Access Compliance Report Public Rights-of-Way (Curb Ramps)

Main Street: TETHER_MOON_LN Cross Street: TERRASTAR_LN Location: SE

ADA ID: RPAT211101095718 Ramp Type: Type 4 - Parallel Initial Pass/Fail: Pass Overall Compliance: No Severity Score: 6

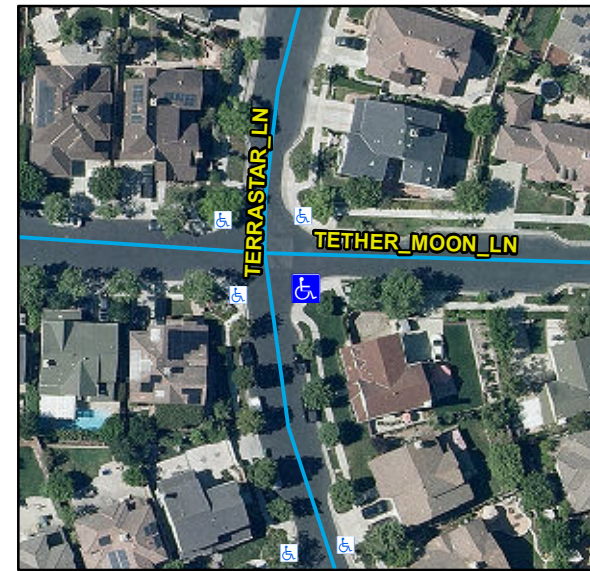
Compliance	Description	Data	Compliance	Description	Data
N/A	Ramp Length LT (in)	100	N/A	Ramp Length RT (in)	101
Yes	Ramp Width LT (in)	53	Yes	Ramp Width RT (in)	53
Yes	Ramp Run Slope LT (%)	8	Yes	Ramp Run Slope RT (%)	1.5
Yes	Ramp Cross Slope LT (%)	1.6	Yes	Ramp Cross Slope RT (%)	0.9
N/A	Landing Present	Yes	Yes	DWS Provided	Yes
N/A	Landing Length (in)	53	Yes	DWS Contrast	Yes
Yes	Landing Width (in)	54	Yes	DWS Length (in)	36
No	Landing Run Slope (%)	3.1	Yes	DWS Full Width	Yes
No	Landing Cross Slope (%)	2.2		DWS Offset Type	Single
N/A	Landing Movement Obstructed?	No	Yes	DWS Offset Left (in)	1
	Landing Movement Type	Curb	Yes	DWS Offset Right (in)	N/A
N/A	Landing Shared	No			
N/A	Clear Space	Yes			
N/A	Clear Space To Crosswalk (in)	48			
N/A	Marked Crosswalk 1	No	N/A	Marked Crosswalk 2	No
	Crossing 1 Direction	W		Crossing 2 Direction	N
	Marked Crosswalk 1 Width (in)	N/A		Marked Crosswalk 2 Width (in)	N/A
N/A	Ramp Inside Crosswalk 1	N/A	N/A	Ramp Inside Crosswalk 2	N/A

Crossing 1 Slope (%)	3.5		Crossing 2 Slope (%)	1.2
	Crossing 1 Cross Slope (%)	1.1		Crossing 2 Cross Slope (%)	3.5
Yes	Gutter Ponding	No	Yes	Curb Slope	4.7
Yes	Gutter Lip Height (in)	0		Road Run Slope (%)	1.4
No	Gutter Run Slope (%)	11.7		Road Cross Slope (%)	2.2
Yes	Gutter Cross Slope (%)	2	No	Perpendicular Joint Present	No
Yes	Overall Surface Condition	Acceptable			
	Cross Gutter Present?	No		Spandrel Present?	No
	Replace Cross Gutter?	N/A		Replace Spandrel?	N/A

Remove & Replace Curb Ramp With Two New Directional Ramps or Equivalent. Remove & Replace Gutter.

R204.3, R304.2.2-Perp, R304.3.2-Para, R304.5.3, R304.5.4, STD 1115
